DEVELOPMENT APPLICATION ASSESSMENT REPORT

Application Number:	DA2021/1164
----------------------------	-------------

Responsible Officer:	Anne-Marie Young
Land to be developed (Address):	Lot 129 DP 16902, 521 Barrenjoey Road BILGOLA BEACH NSW 2107
Proposed Development:	Construction of a Dwelling House including a swimming pool
Zoning:	C4 Environmental Living SP2 Infrastructure
Development Permissible:	No - Zone SP2 Infrastructure Yes - Zone C4 Environmental Living
Existing Use Rights:	No
Consent Authority:	Northern Beaches Council
Delegation Level:	NBLPP
Land and Environment Court Action:	No
Owner:	Peter Michael Sydney Madew
Applicant:	Peter Downes

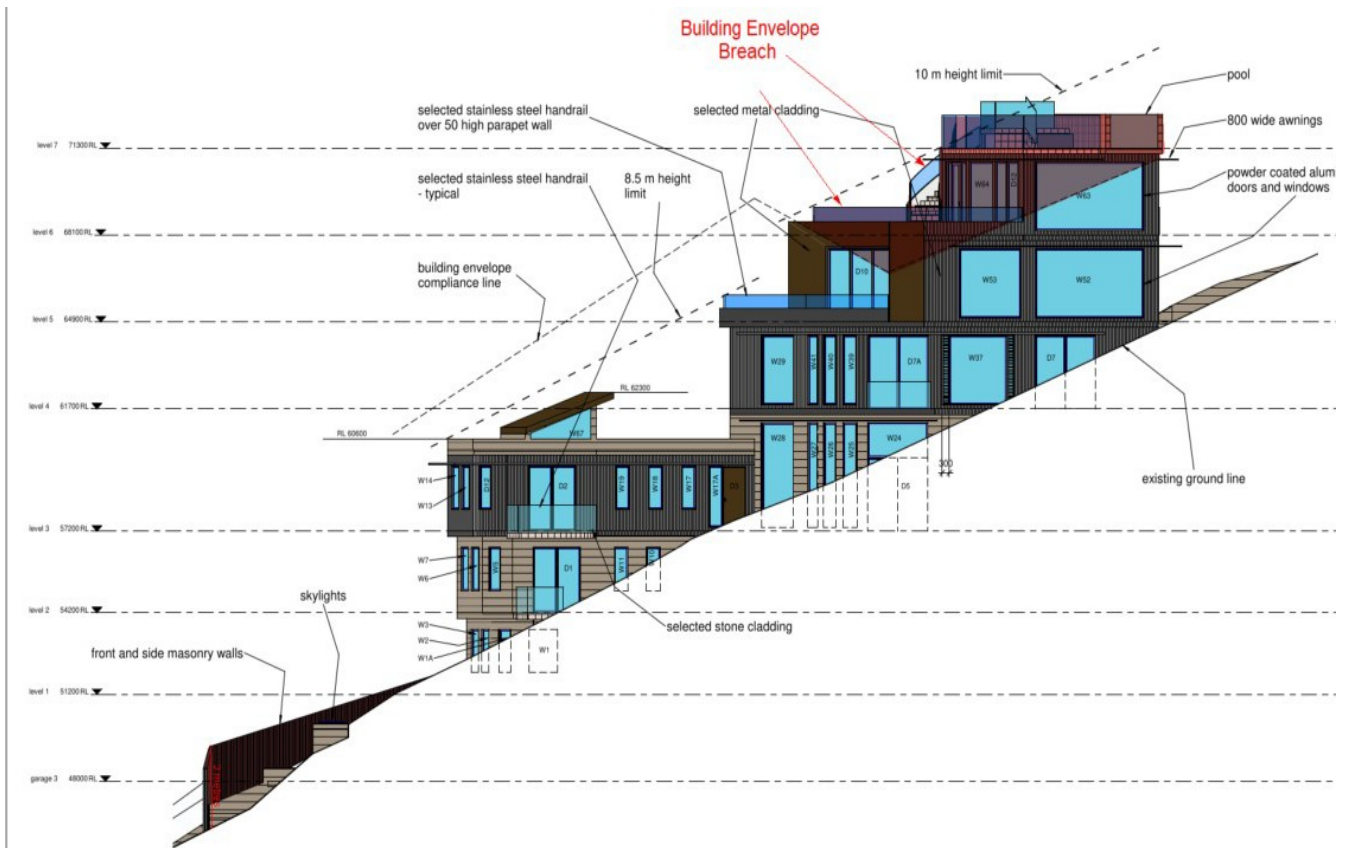
The proposal breaches the envelope along the east and west elevation as follows:

Building Envelope Breach West elevation (source Peter Downes)

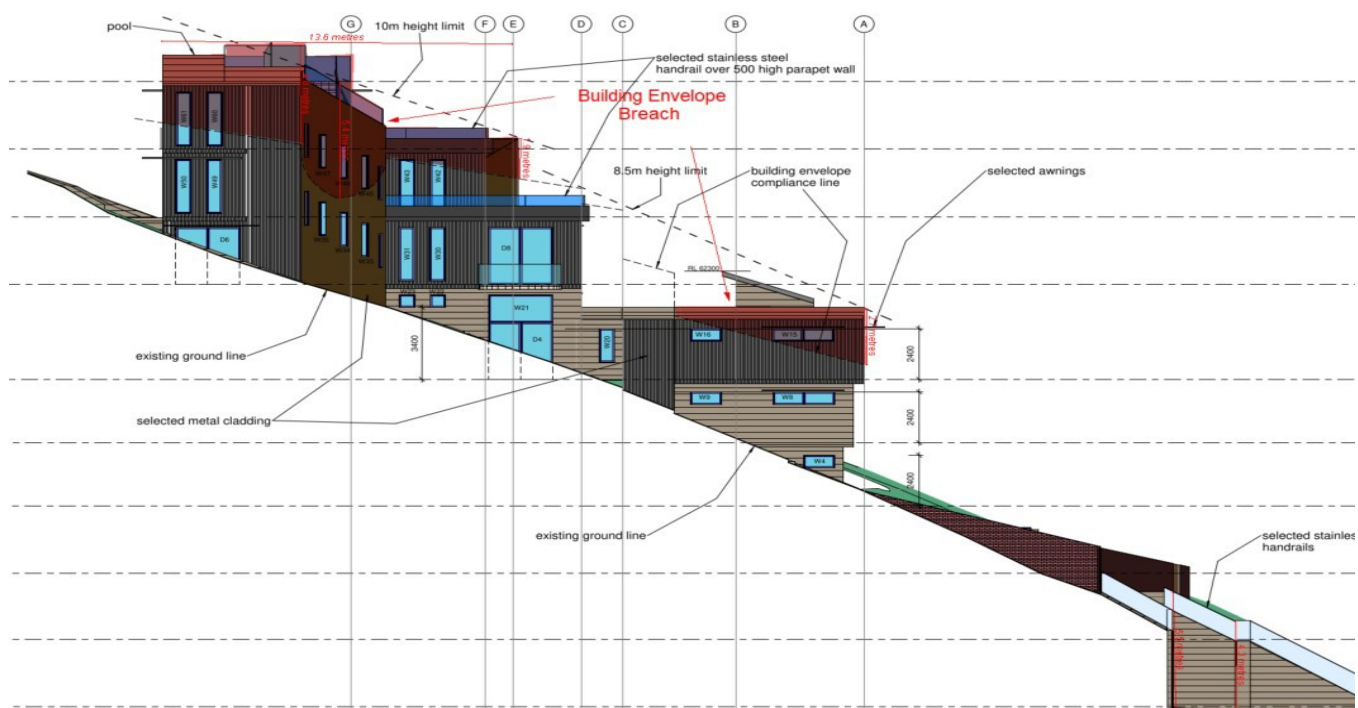
The west elevation includes two areas of envelope breach:

- studio / offices (0.5m - 2.8m in height x 7.6m in length), and
- dwelling (1.3m - 5.4m in height x 13.6m in length), refer to image below.
